# Questions from Spring Harbor Comment Period

6/13/21—The City received a variety of questions and comments from residents. Where questions were similar, the City summarized the main question in the “Generalized Question,” responded to that, and listed the specific questions from residents that the generalized questions is addressing beneath, where applicable.

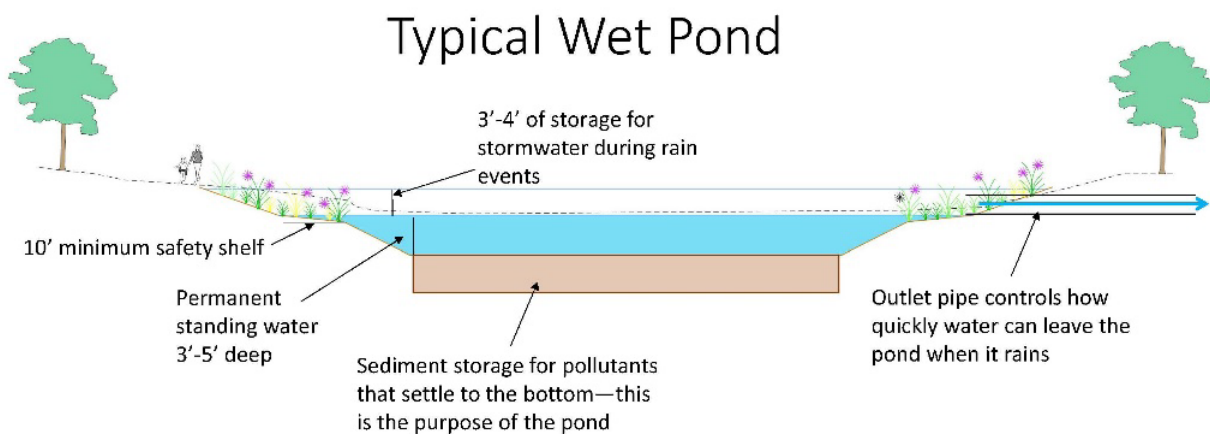
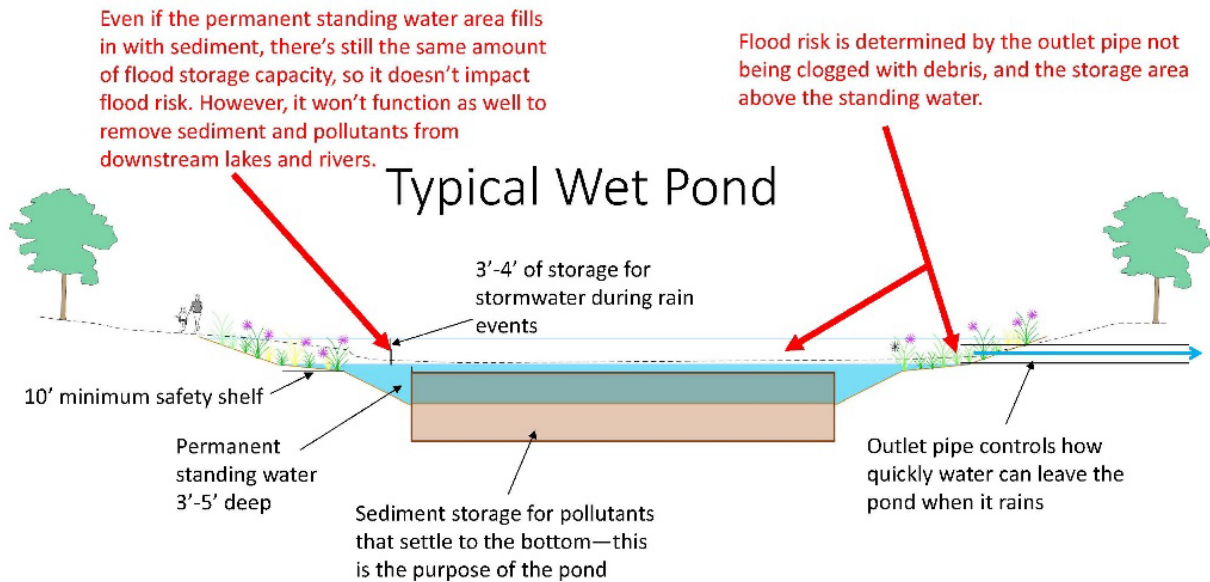
14. Question: Impact of putting in a properly sized culvert at Regent Street, and why it cannot be used for additional storage?

- *In particular, the Regent St underpass is reported as undersized in the Final Draft Report. If that is going to be upsized, there are multiple opportunities to engineer a solution beneath Regent St, including oversized box culverts, storage volume, etc.*

Response: There is 500 cfs of stormwater that flows through the Kenosha Greenway during a 1% chance event. That is the equivalent of 75,000 garden hoses turned on. Or, if you can imagine pulling a string from one side of a greenway to the other, the volume of water moving past is equal to ~500 basketballs passing under that string every second.

In order to create enough storage under Regent Street to reduce stormwater flows and nearby flooding, you would need to be able to hold thousands of cubic feet of water (or, imagine basketballs) beneath the road. Unfortunately, that space doesn't exist.

There is only space to move water under the street, not create a huge cavity for storage under the street. This is due to limited footprint of the road, and the surrounding existing utilities. For more information on the infrastructure under our streets, please visit our [Hidden Infrastructure](#) webpage, and our [Flash Flooding Resilience storymap](#).

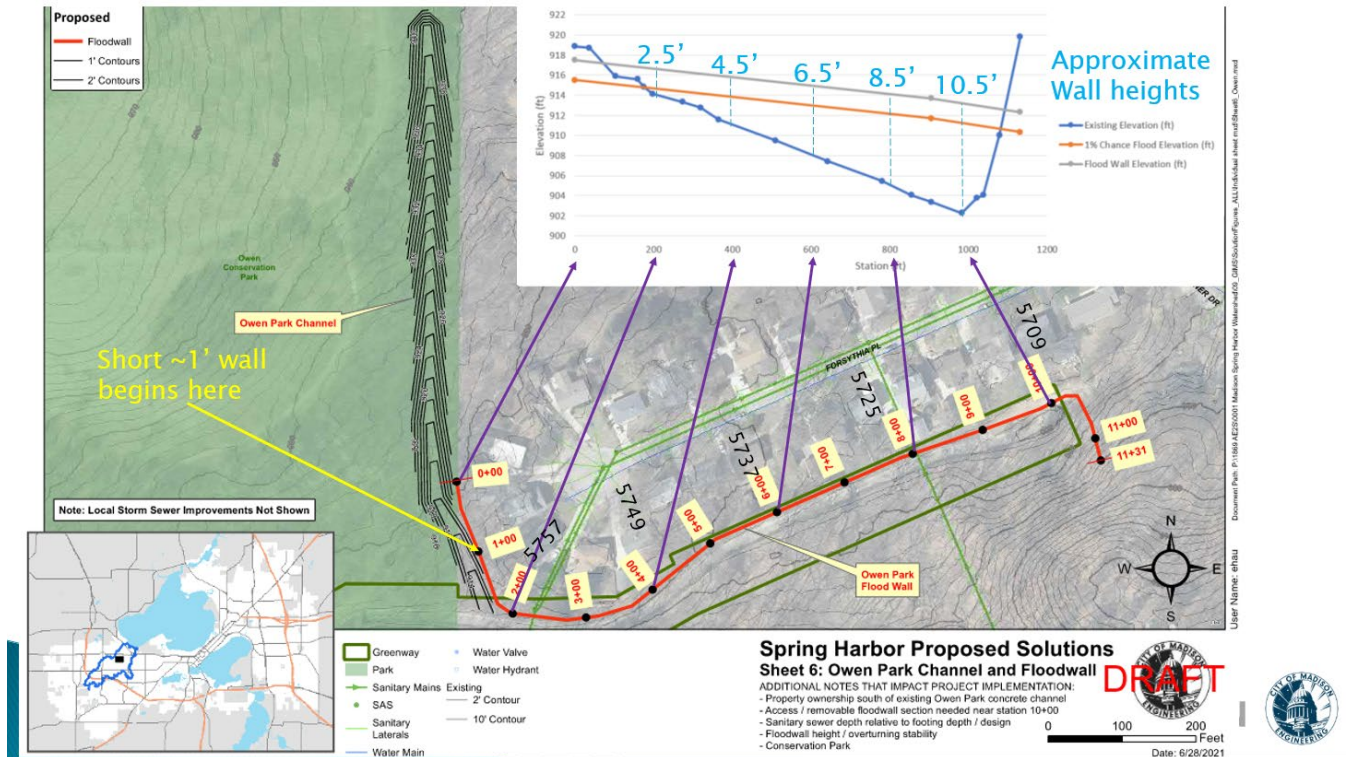
11. Generalized Question: I also wonder when it comes to the flood wall height where does the bottom of the flood wall begin? Is it at the top of the concrete cunnette?

Response: The conceptual solutions proposed for the flood wall to begin at the top of the berm. However, the final details of the flood wall location and specific heights would be figured out if and when the project is budgeted, during the detailed design process.

Here is a drawing that more clearly shows the approximate wall heights along the cunnette that was shared with the Crestwood Neighborhood Association. Note, these are all based on the conceptual solution and would change based on the detailed, final design once the project is budgeted.
